Zeus Propeller Shaft Repair Kit, 8M0075212

Models Affected

Situation

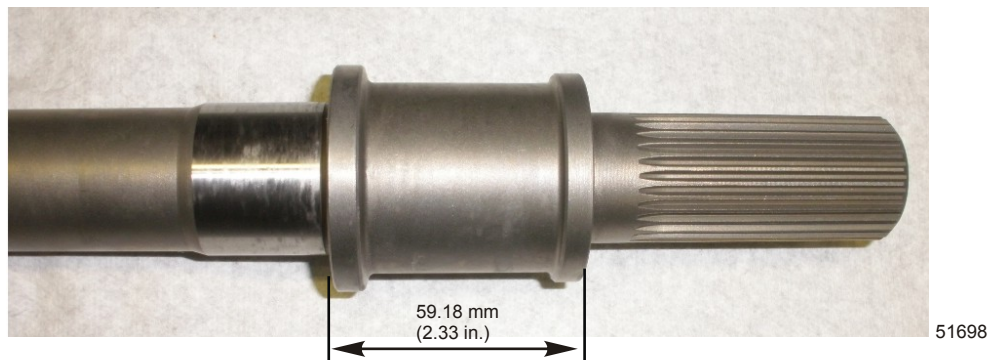
Due to design changes, the existing outer propeller shaft kit, 879150A69, is not compatible on the Zeus pods shown above. A new propeller shaft kit, 8M0075212, has been released, and is to be used on such pods. This kit includes the outer propeller shaft, inner propeller shaft, pinion, front gear, and bearing assembly.

In addition, inner propeller shaft 879148T17 will be superseded by this new propeller shaft kit.

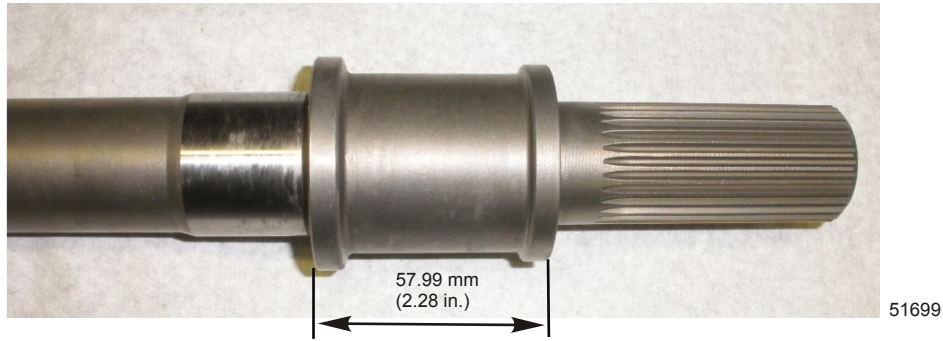
If the inner propeller shaft flange to flange dimension of 59.18 mm (2.33 in.) is as follows, order propeller shaft kit 8M0075212, when replacing either or both of the propeller shafts.
